Access Compliance Report

Public Rights-of-Way

(Curb Ramps)

Intersection ID: 22285	Main Street: QUAIL_HOLLOW_RD	Cross Street: HAMPTONRIDGE_DR	Location: SE
ADA ID: 416963B1A1CD	Ramp Type: PerpDiag	Initial Pass/Fail: Fail	Overall Compliance: No
Severity Score: 26.25			
Codes/Mitigation Info/Possible Solution		Field Measurements/Component Compliance

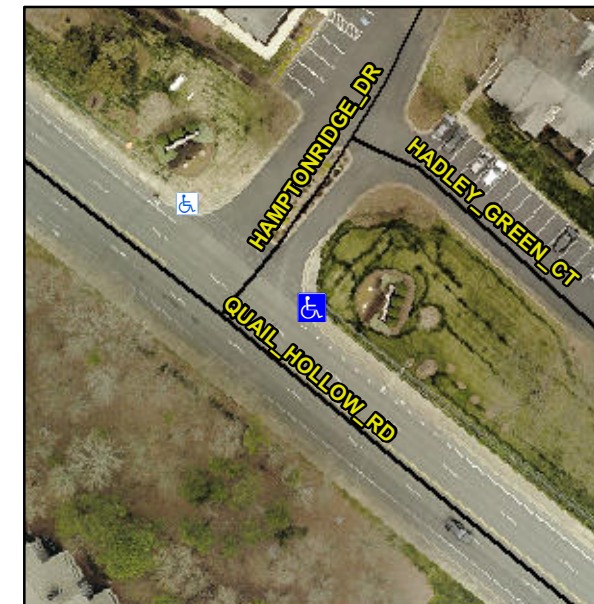
Not Found, R304.2.2, R304.5.3

Compliance	Description	Data	Compliance	Description	Data
N/A	Ramp Length (in)	63.0	No	Ramp Slope (%)	14.3
Yes	Ramp Width (in)	48.0	No	Ramp XSlope (%)	4.7
N/A	Flare Type LT	N/A	N/A	Flare Type RT	N/A
N/A	Flare Slope LT (%)	N/A	N/A	Flare Slope RT (%)	N/A
N/A	Flare Traversable LT?	N/A	N/A	Flare Traversable RT?	N/A
N/A	Landing Length (in)	N/A	N/A	DWS Provided?	N/A
N/A	Landing Width (in)	N/A	N/A	DWS Contrast?	N/A
N/A	Landing Slope (%)	N/A	N/A	DWS Length (in)	N/A
N/A	Landing X Slope (%)	N/A	N/A	DWS Full Width?	N/A
N/A	Landing Curb? (Y/N)	N/A	N/A	DWS Offset (in)	N/A
N/A	Shared Landing?	N/A			
N/A	Gutter Ponding?	N/A	N/A	Gutter Slope (%)	N/A
N/A	Gutter Lip Ht (in)	N/A	N/A	Gutter X Slope (%)	N/A
N/A	Painted X Walk1?	No	N/A	Painted X Walk2?	No
	X Walk 1 Direction	To NW		X Walk 2 Direction	To SW
N/A	X Walk 1 Width (in)	N/A	N/A	X Walk 2 Width (in)	N/A
	X Walk 1 Slope (%)	1.0		X Walk 2 Slope (%)	0.8
	X Walk 1 X Slope (%)	4.8		X Walk 2 X Slope (%)	2.4

Remove & Replace Curb Ramp With Two New Directional Ramps or Equivalent.
